**CALIFORNIA GEOLOGICAL SURVEY
FAULT EVALUATION REPORT FER 253
SUPPLEMENT NO. 1**

**THE HOLLYWOOD FAULT
in the Hollywood 7.5' Quadrangle
Los Angeles County, California**

by
Janis L. Hernandez
Engineering Geologist
November 5, 2014

PUBLIC COMMENTS, AND RESPONSE

Figure 3 – Study site locality S1-1 indicated in blue shaded area. Boring transect shown as dark blue patterned line. Previous study sites included in the initial FER shown in light green.

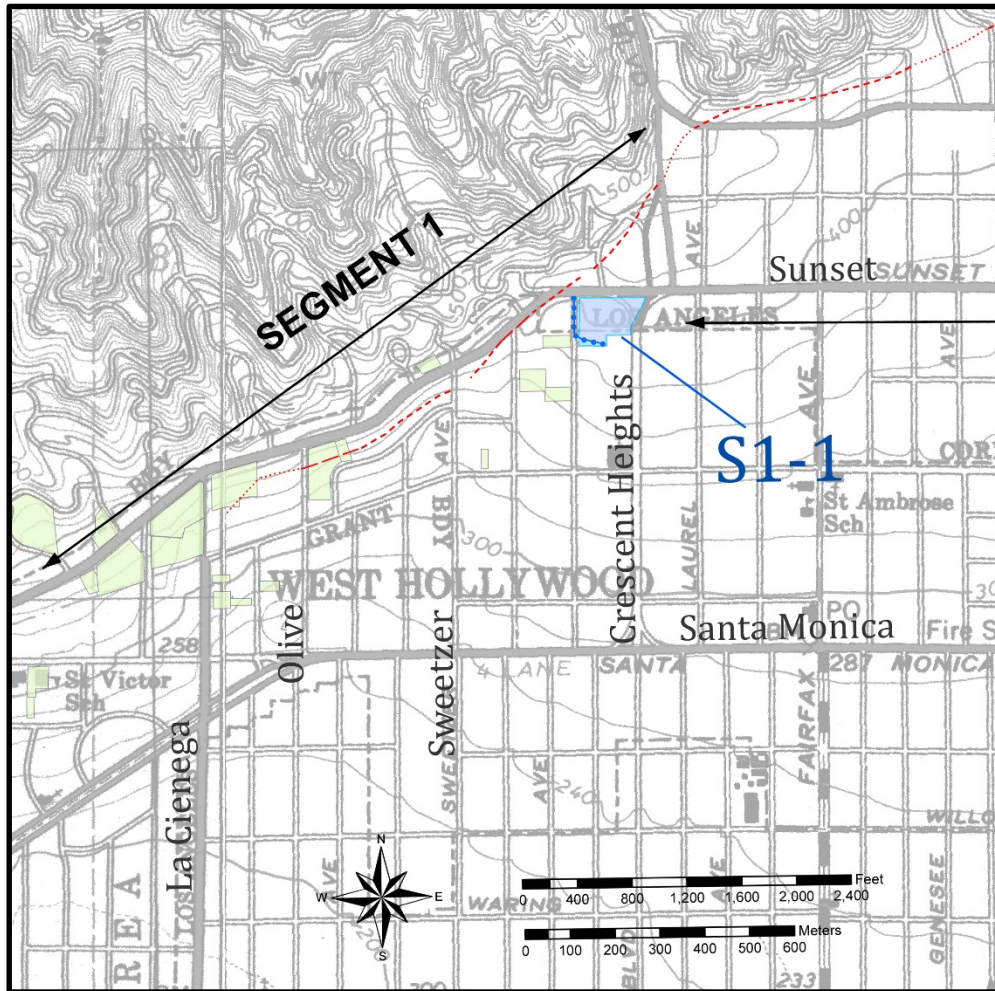
Golder Associates, Inc. (2014a, b) prepared a Surface Fault Rupture Hazard Assessment and Geotechnical Exploration study for a residential and commercial development located on the southwest corner of Sunset Boulevard and Crescent Heights (locality S1-1) as shown on Figure 3. Golder's site evaluation included a CPT transect and hollow stem auger boreholes along the western and southern site boundaries. They interpreted this transect to show continuous alluvial stratigraphy across the site. They reported silts and gravelly sands deposited less than 7 thousand years ago (ka) to depths of about 40 feet. Lower deposits ranged in age from 9 ka to 13 ka at depths of about 60 to 80 feet. They concluded the site has not had major disruption from Holocene faulting.

The data presented by Golder Associates are consistent with the interpretation presented in the initial FER that the Hollywood Fault lies north of this site as shown on the preliminary Alquist-Priolo Earthquake Fault Zone map.

Figure 4 – Index map showing new localities S2-1 and S2-2. Trench locations indicated as orange line segments. Previous studies included in original FER shaded green.

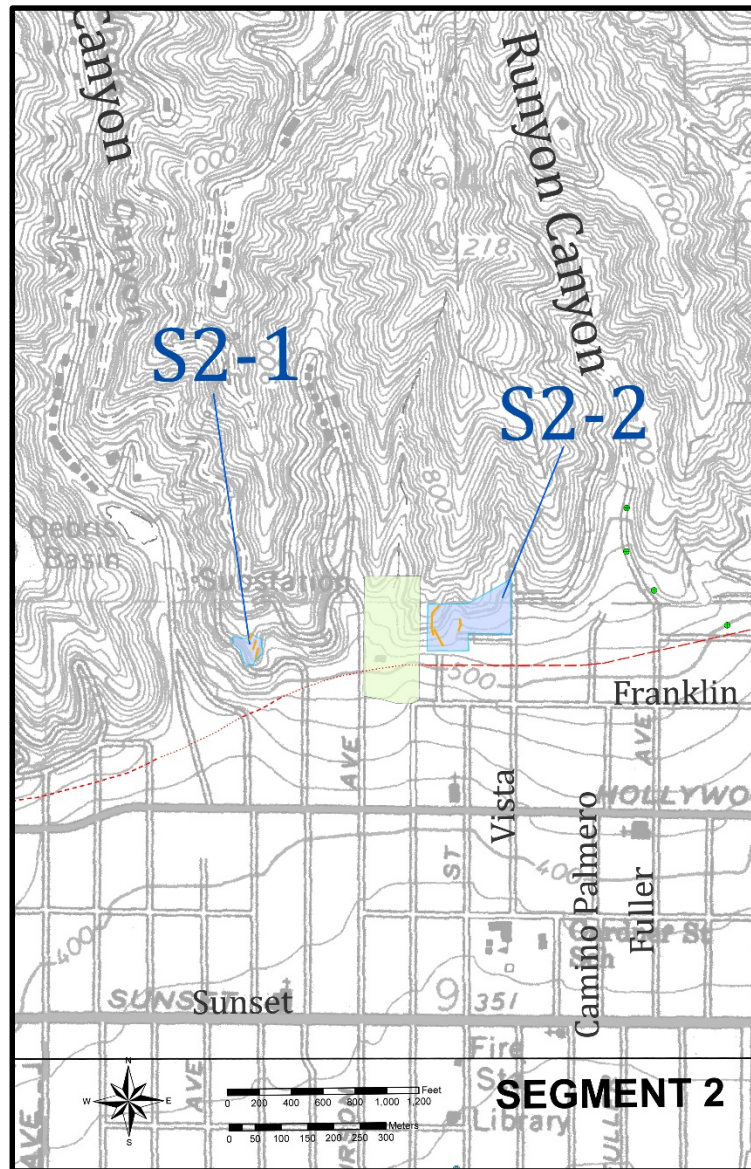
Irvine Geotechnical, Inc. (2014) performed a fault investigation for a residential project located near the base of the Santa Monica Mountains at locality S2-1 (Figure 4). Geologic mapping and shallow trenches were performed as part their study. A geologist for the City of Los Angeles observed the excavation during the study, where un-faulted quartz diorite bedrock was exposed.

Grover Hollingsworth and Associates, Inc. (2014) conducted a fault investigation for a project located along the southern edge of the Santa Monica Mountains, near Runyon Canyon at locality S2-2 (Figure 4). They excavated three fault trenches across the site and observed a thin layer of soil overlying quartz diorite bedrock. Caliche-lined faults were observed in Trenches 1 and 3, but clay gouge and slickensides were not observed in the fault zone. With field review and discussion with the City of Los Angeles geologist, Grover Hollingsworth considered these faults to be pre-Holocene.

The data presented by Irvine Geotechnical and Grover Hollingsworth and Associates for localities S2-1 and S2-2, respectively, is consistent with the interpretation that no Holocene faults cross these sites north of the fault shown on the preliminary Alquist-Priolo Earthquake Fault Zone map.

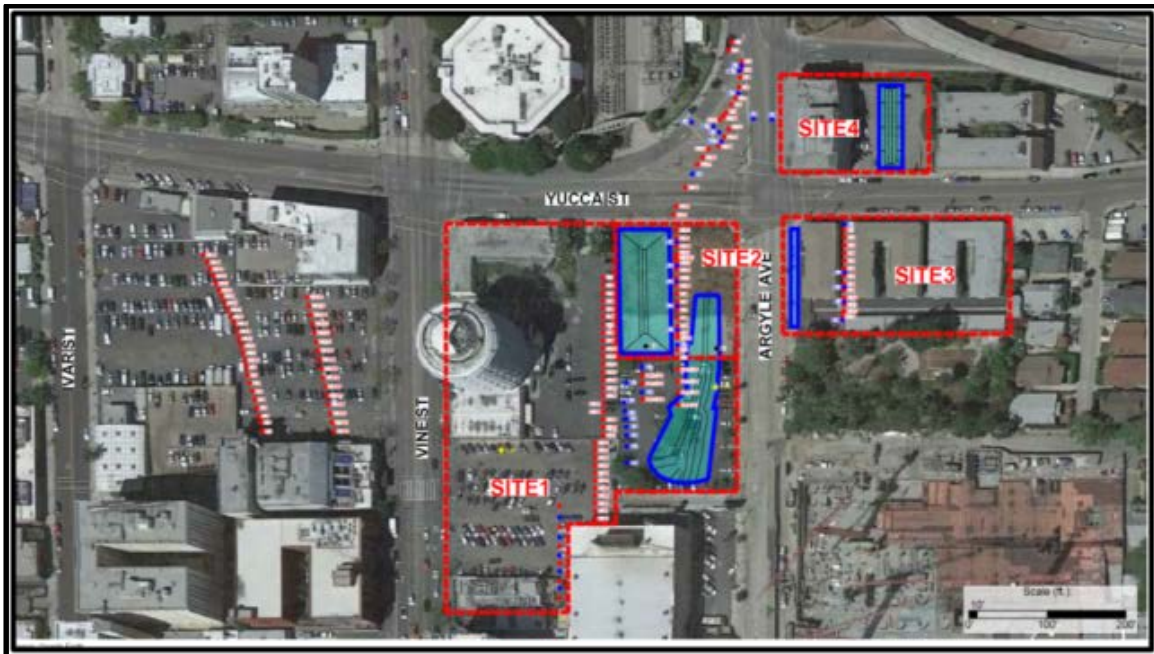
A comment was submitted by Mr. Michael Reader of Group Delta Consultants, Inc. (GDC) on March 13, 2014 to the SMGB for locality S2-8 (GDC Site 2, Figure 8). Mr. Reader stated that although there are mapped locations where the Hollywood Fault is somewhat well-defined, in the area between Cahuenga Boulevard and Gower Street the Hollywood Fault is concealed by alluvial fans, and that no data in this area have located the active trace. He also reported that the geologic community agrees the active trace of the Hollywood Fault lies “somewhere” in this area. However, he questioned the delineation of the zone for this area, with such sparse available data.

A fault study, conducted by Group Delta Consultants, Inc. (2014a) was submitted to the SMGB on May 6, 2014 for locality S2-8 (GDC Site 2, Figure 8). This study included core boring and CPT transects and an approximate 100-foot long, 30 foot deep trench on the western portion of the site. GDC reported that they found no evidence for faulting in the Holocene units on this site. The study also reported age estimates of weathered soil horizons at two locations within the trench, prepared by Dr. Roy Shlemon, and included test results from two charcoal samples submitted for C14 dating.

GDC reported the site is underlain by fluvial channel deposits, locally named the Argyle Channel, which they estimate to be Holocene. Underlying the Argyle Channel deposits, they report a clayey sand layer. The contact between the lower clayey sand and the overlying Argyle Channel sands is reported to be an erosional unconformity. The lower clayey sand is reported to be at least 12 to 15 ka, based on relative soil pedogenic development exposed in the trench. Age estimates by GDC are based on soil development described by Dr. Roy Shlemon, in Appendix B of their report, and correlation of the unconformity with ice age sea-level low stand at during marine isotope stage 2. Radiocarbon dates reported for the Argyle Channel deposits were about ~4.3 ka, and ~41 ka at about 14 feet, and 18 feet below the ground surface (bgs), respectively. GDC prefers the soil-stratigraphic and paleo-environmental age estimates for the Argyle Channel deposits and does not use the radiocarbon dates.

A second Fault Activity Report was submitted by GDC for locality S2-8, dated September 3, 2014 (Group Delta, 2014b). This investigation consisted of additional CPT and core borings from adjacent sites in the vicinity, and an additional trench located on the eastern portion of the site that also extended south into GDC Site 1 (locality S2-9). During this second investigation, GDC reported a bedding plane fault underlies the site, where they concluded this fault is overlain by a buried paleosol “indicative of about 30 ka of weathering.” This trench was excavated in response to comments by the City of Los Angeles noting that faulted Pleistocene sediments were found directly across the street to the east (GDC, Site 3; locality S2-11). Within this eastern trench at locality S2-8, Argyle Channel deposits were exposed, underlain by mudflow deposits (previously referred to by GDC as the clayey sand or “basal clay” unit). Underlying the mudflow deposits they reported well-consolidated older alluvial debris flow deposits that are dipping gently to steeply to the south. C14 dates near the base of the Argyle Channel deposits were reported at ~4.1 to 4.3 ka. (Group Delta, 2014a, 2014b). The soil ages within the trench were derived from soil profile descriptions from R. Shlemon. GDC concluded that folding and related slip observed in their trench occurred prior to deposition of the mudflows, capped by a remnant buried paleosol of about 30 ka, and are overlain by the unbroken, estimated ~12 ka Argyle Channel deposits.

The data presented in the GDC report appear to be consistent with the interpretation that the Argyle Channel deposits are of Holocene age. However, multiple C14 samples GDC reported within their trenches near the base of the Argyle Channel, are only ~4.3 ka and thus the channel deposits do not represent the complete Holocene record. We consider the Argyle Channel deposits to be approximately 6 ka, based on C14 data throughout the two trenches, and related soil development. The interpretation that the underlying clayey deposit is pre-Holocene appears to be consistent with the reported data. Detailed analysis of the soil profile development was prepared by G. Seitz, of CGS, and is included in Appendix A of this supplement. This analysis includes further comments regarding the reported age classification of the Argyle Channel deposits, and underlying clayey sand unit.

The data presented in the GDC report regarding faulting of these deposits is also open to alternate interpretations. The trench log and correlation by GDC show that Argyle Channel deposits are unfaulted across much of the site. CGS performed a field review of the west trench on two occasions, the first was not extensive enough to verify all of the consultant's conclusions due to safety concerns, however a subsequent visit afforded the opportunity to view the clayey sand deposits and relative soil development at the base of the trench. Our review of the CPT and core boring data for GDC Site 2 finds the Argyle Channel sand unit appears to be continuously correlated between borings and CPT tests, however the underlying clayey sand unit is shown to be discontinuous across portions of the site. Our review further notes the cross sections illustrated by GDC favor the CPT correlations, where core boring data in some areas does not directly support their stratigraphic interpretation.

Based on this new trench data, as well as other data, we have relocated the northern fault strand to project along Yucca Street toward the north. The southern fault strand is also modified in this area based on data from locality S2-9 (GDC Site 1), described below.

Figure 11 – Cross-section from GDC Site 3 showing anticlinal folding of Pleistocene debris flow deposits, inferred stratigraphic form lines and faults that offset this unit. Numbered annotation at each fault reflects GDC’s observed stratigraphic separation at each location. Figure from GDC, 2014c.

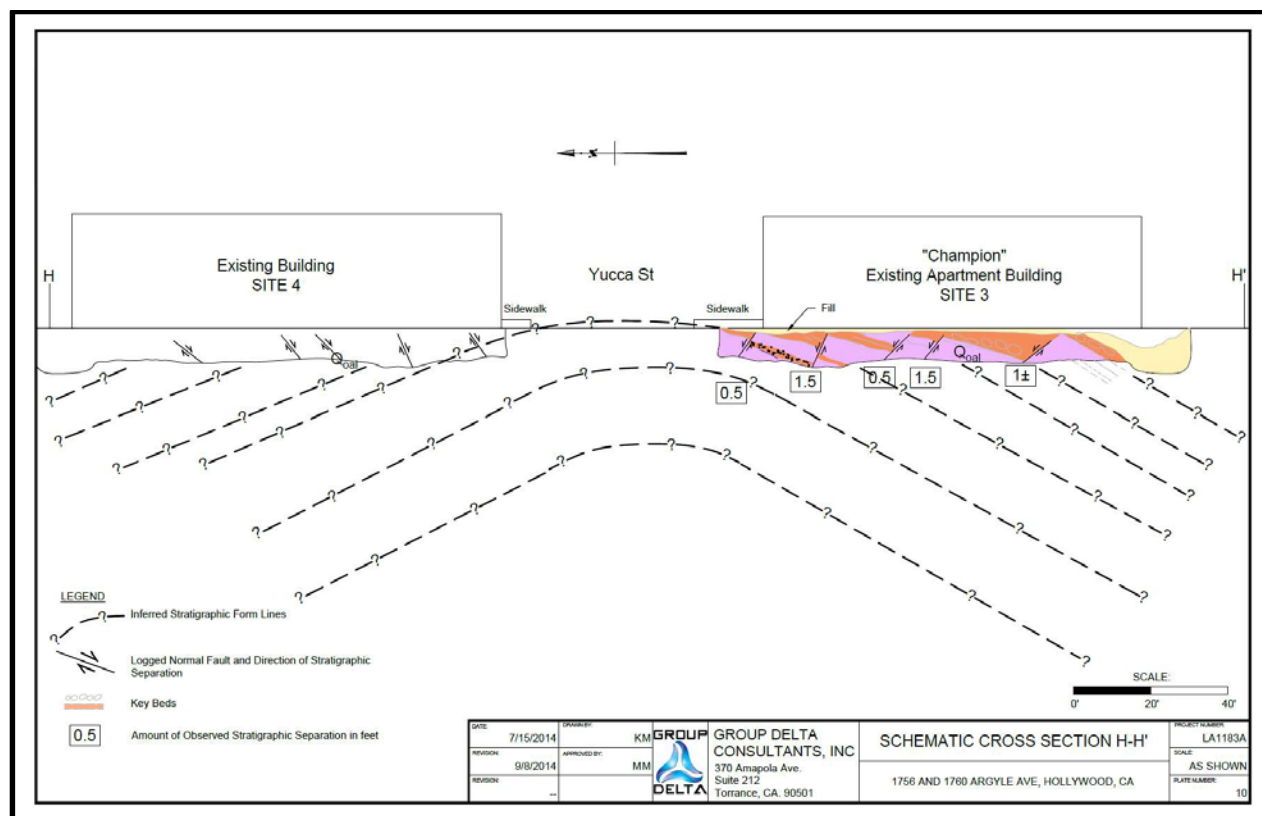
At locality S2-11, (GDC Site 3, Figure 8), Group Delta (2014c) reported the site is underlain by fill materials and older alluvial debris flows, which in turn are underlain by Modelo Formation. Their site investigation included both CPT and core borings, and an approximate 8-foot deep trench on the west side of the site. GDC reported the older alluvial unit consists of Pleistocene debris flows, and state that this unit is faulted. They associated this fault with a localized west-northwest oriented anticline, which extends north to GDC Site 4, as shown in their cross-section (Figure 11). They interpret these features to be due to regional transpression and not to seismogenic faults. They report the age of the faulting at this site is older than 35 ka based on unbroken mudflow deposits found to the west at Site 2.

The data presented in the GDC report is consistent with the interpretation that the deposits are of Pleistocene age although it is unclear why these “debris flow” deposits are differentiated from the similarly comprised and deformed older alluvial fan unit exposed and described at site 2.

Interpretation that the faults are local bending moment faults is not consistent with CGS field observations within the trench. CGS noted a significant lack of correlation across the southernmost fault, and that thickness of units changed across most of the faults, which indicates a component of lateral displacement (Figure 12). The southernmost fault appeared to be a prominent fault, as correlative units across the fault were not found, suggesting this fault trace may have seen the most displacement. No evidence for, or against, Holocene faulting was reported on this site because Holocene deposits, if present, were likely removed during site development.

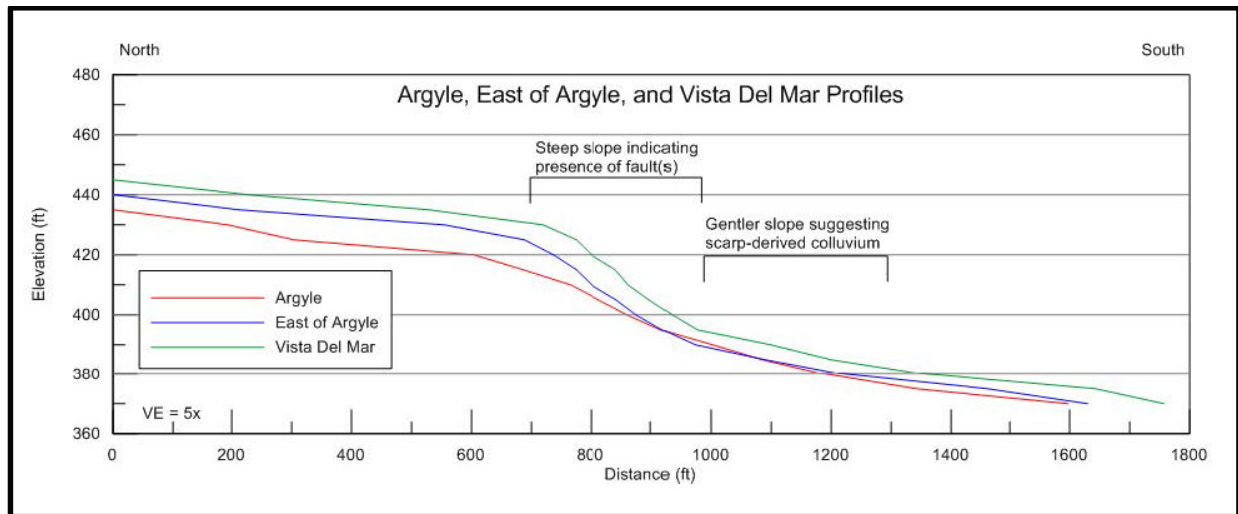
A comment was submitted by Lettis Consultants International, Inc. (LCI), accompanied by a transmittal letter by Elkins Kalt Weintraub Reuban Gartside, LLP on April 8, 2014 to the SMGB to specifically address the BLVD 6200 property located at 6201 Hollywood Boulevard in Hollywood (locality S2-12, Figure 7). In their report, they present data and analysis of the site and vicinity, with additional focus on the southern, discontinuous trace of the Hollywood Fault that is mapped on the Preliminary EFZ map to underlie the site. LCI presented detailed topographic profile analyses consisting of 3 sets of data including: review of historical 6-minute topographic maps, high-resolution lidar imagery, and high resolution ground survey topographic profiles along 8 closely-spaced, north-south oriented streets. These profiles were located within the streets adjacent to the BLVD 6200 site and along other nearby profile lines. They identified breaks in slope within the profiles of these transects, and included locations of scarps previously mapped by Dolan et al. (1997), the projection of fault traces mapped by CGS in FER 253, and the BLVD 6200 project boundary.

LCI stated that in addition to the prominent break in slope located immediately north of their site, a subtle break in slope is expressed across the southern portion of the site. They reported this southern slope break is located south of the southern discontinuous fault trace mapped by CGS. They suggest that subtle breaks in slope can be related to several factors: change in slope direction on the ground surface, or thickness and directional changes within the alluvial fan system. Their analysis noted that the subtle slope break is coincident with an east-west trending apparent scarp mapped by Hill et al. (1979), and a possible fault scarp mapped by Weber et al. (1980). In their review of the 1926 topographic maps, they indicated that Argyle Avenue did not yet exist at this location, and that possibly the subtle break in slope observed in the street may have been created during subsequent construction of Argyle. Alternatively, they concluded that this subtle break in slope reflected in the composite topographic profiles (Figure 13), is most likely related to scarp-derived colluvium from the steep break in slope to the north.

The data presented in the LCI report was particularly helpful in CGS review of topographic breaks in slope. Fault traces mapped by CGS in this area were based on geomorphic interpretation using similar data as used by LCI, as well as fault traces from Dolan et al. (1997), Hill et al. (1979), and Weber et al. (1980). In addition, the southern discontinuous fault trace was mapped using original subsurface data from Geotechnologies, Inc. (2006) that included logs of borings and the site topographic base map. CGS review of the high resolution street survey data submitted by LCI in their report, and detailed observations included in the Geotechnologies (2013) report, finds justification to modify our interpretation of the location of the principal southern fault trace.

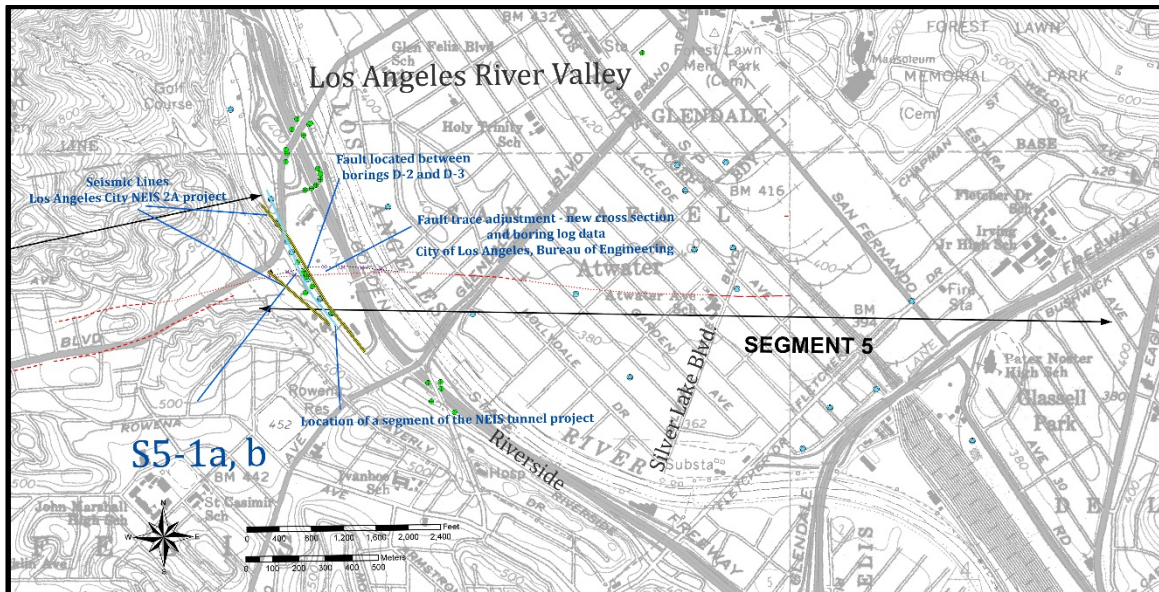
David L. Perry, comment letter dated April 18, 2014: Mr. Perry submitted a comment to the SMGB on April 18, 2014 regarding the location of the Hollywood Fault and analysis of the supporting data from the Northeast Interceptor Sewer (NEIS2A) project area (locality S5-1a) as shown on Figure 15. In this letter, Mr. Perry reports the cross-section utilized in the FER (from the Los Angeles Department of Public Works, 2013) is vertically exaggerated, and includes borings that were projected up to 63 feet horizontally into the section. In the AMEC (2013) report, he states there is a cross-section drawn at a 1:1 scale, and acknowledges subsequent boring data performed by the City of Los Angeles Department of Public Works (City of Los Angeles, 2013) was included in the cross section utilized by CGS for the FER. Mr. Perry's interpretation of the data, and his extensive experience in this area suggests the "thickening of young alluvial deposits within the fault zone" as reported by CGS, is likely attributed to paleochannels from the Los Angeles River system, and that the projection of the data into the cross-section should include consideration of geomorphology and paleochannel geometry.

Patrick Schmidt, and Fred Burnett, (2014): Mr. Schmidt and Mr. Burnett of the City of Los Angeles Bureau of Engineering (BOE) provided CGS a technical paper they prepared in February, 2014 that was submitted to the Underground Construction Association's North American Tunneling Conference (NAT). In this paper, they discussed some of the exploratory methods implemented during the Northeast Interceptor Sewer project (NEIS), including: borings with down-hole geophysics, packer and pressuremeter testing, CPT testing, Remi surveys and surface geophysics lines. They reported some of the difficult conditions they anticipate encountering during tunneling along the fault zone, including: squeezing and running ground conditions, high methane gas concentrations, and up to 5 bars of water pressure. They reported the main Hollywood Fault was located between exploratory borings M08-B4 and M08-B5, where interpolation of the geophysical surface survey data identified two north dipping fault planes with three south-dipping secondary faults in the hanging wall that merge at depth.

We reviewed Mr. Perry's comments, and appreciate the insight he provides in this area, and particularly with his experience on the NEIS project. Regarding projection of data into the NEIS profile, we acknowledge the thickness variation of recent alluvium in the vicinity of subsurface faulting may be due to erosion processes, and paleochannel morphology along the ancestral Los Angeles River system.

Our review of the updated cross section and boring logs received from the City of Los Angeles (locality S5-1b), finds that the original projected surface trace of the fault should be shifted to the south approximately 90 feet. We have revised the location of the fault trace based on this new cross section and supporting data. A corresponding revision of the zone boundary has been made.
